Agenda Item # 2 - HOLDOVER

SUB-003642-2026

Willis-Sermon Connector Subdivision

WILLIS-SERMON CONNECTOR SUBDIVISION

DETAIL SITE PLAN

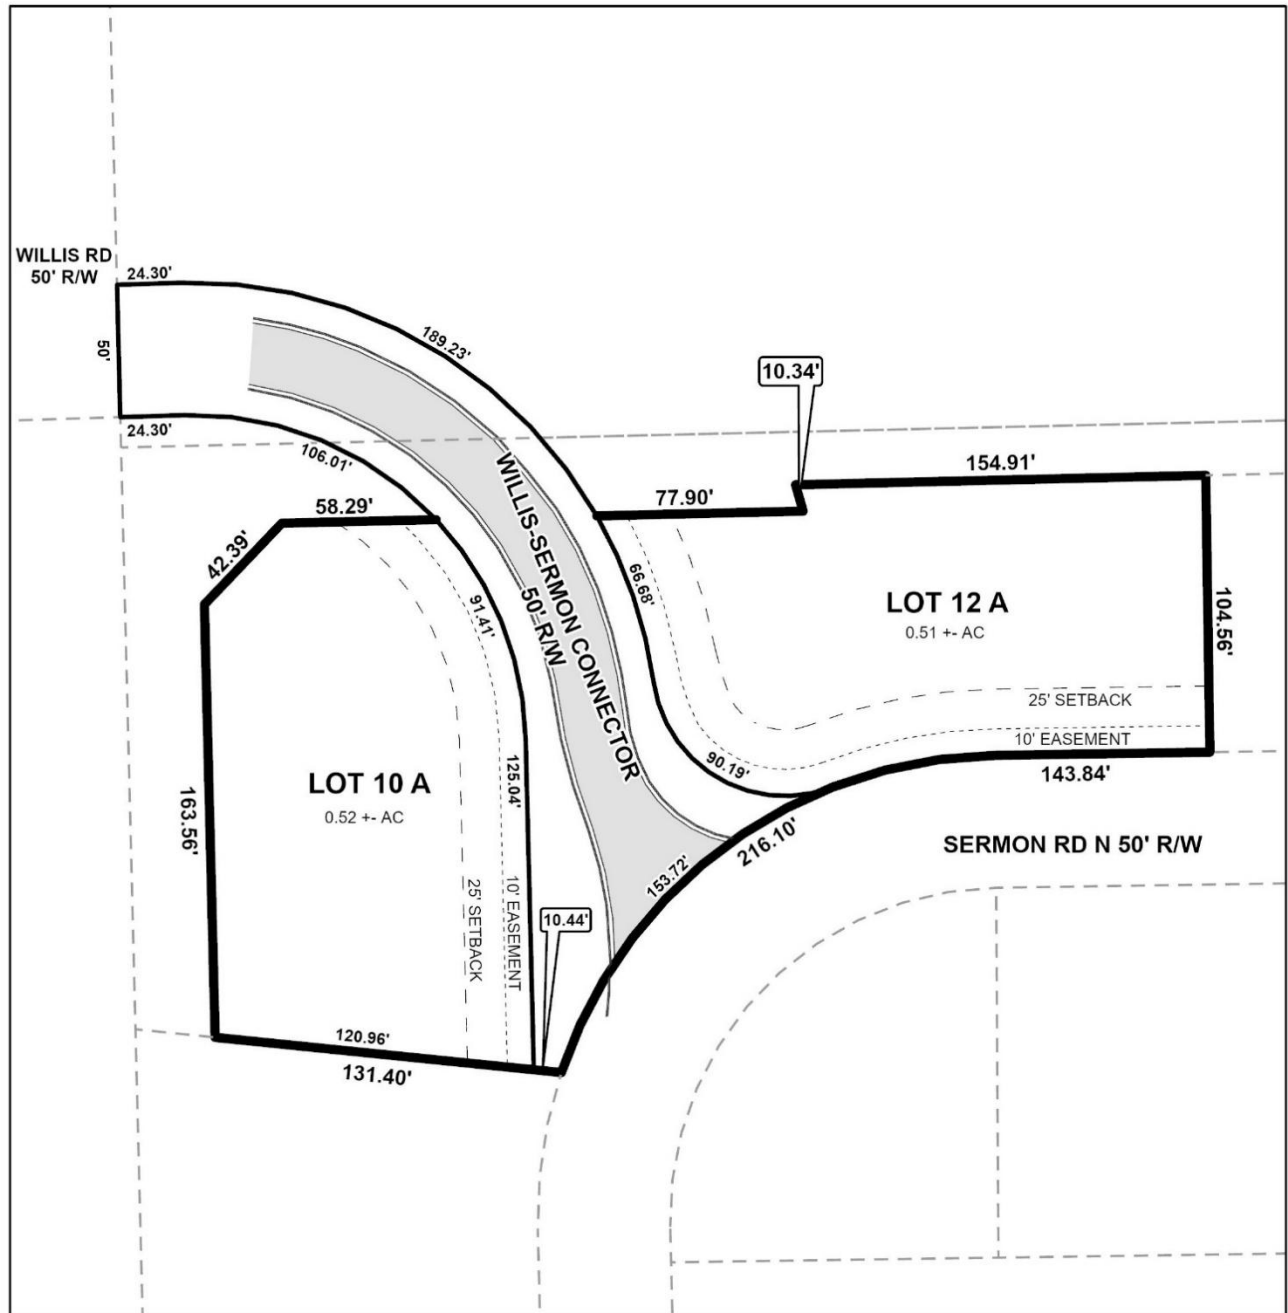
- A. Provide all of the required information on the SUBDIVISION PLAT (i.e. signature blocks, signatures, certification statements, written legal description, required notes, legend, scale, bearings and distances) that is required by the current Alabama State Board of Licensure for Professional Engineers and Land Surveyors.
- B. The existing COMMON AREA (DETENTION) – Parcel 023308273000025.000 – is being split into two 92) separate parcels with the dedication of the proposed ROW. Also, a portion of Parcel 023308273000020.001 is proposed to be added to the western side of the existing COMMON AREA (DETENTION). The new parcels will

need to be labeled with a unique designation (i.e. COMMON AREA (DETENTION) #1 and COMMON AREA (DETENTION) #2)

- C. Show the “old” lot line of the COMMON AREA (DETENTION) that bisects the proposed ROW.
- D. SURVEYOR’S NOTES #7 – include the amount of ROW dedication (acres and SF).

- E. SITE DATA TABLE – provide the exact length of the proposed street centerline.
- F. Review and revise the written legal description to include a written bearing and distance near Lot 6.

- B. *Provide a written description for the subdivision boundary. The ROW description is correct; however there needs to be a separate written description for the subdivision on the west side of Willis-Sermon Connector (LOT 10-A and Common Area- A) and for the subdivision on the east side of Willis-Sermon Connector (LOT 12-A and Common Area- B). There should not be four (4) separate written descriptions for the 2 lots and 2 common areas.*

- C. *Provide the printed name of the “Managing Member” in the Owner signature block.*
- D. *Add a signature block for the Planning Commission.*
- E. *Email a pdf copy of the FINAL SUBDIVISION PLAT and LETTER OF DECISION to the Permitting Engineering Dept. for review at land.disturbance@cityofmobile.gov prior to obtaining any signatures. No signatures are required on the drawing.*

The preliminary plat indicates that the connector street is located not only within the boundaries of the recorded *Collins Subdivision, First Addition*, but also extends into the boundaries of *Collins Property Subdivision*, a one (1)-lot subdivision immediately north of the subject site that is not included in the current application. Because the proposed subdivision would alter the boundaries and area of that subdivision, *Collins Property Subdivision* should also be incorporated into the current application, which would revise the proposal to create three (3) lots rather than two (2).

Additionally, the recorded plat of *Collins Subdivision, First Addition* identifies a Common Area intended for detention purposes that is bisected by the proposed subdivision. This Common Area would therefore need to be included within the boundaries of the proposed subdivision. As the recorded plat establishes that the Common Area is the responsibility of the property owners within the subdivision, all current property owners within *Collins Subdivision, First Addition* would need to sign a consent form authorizing submission of the application.
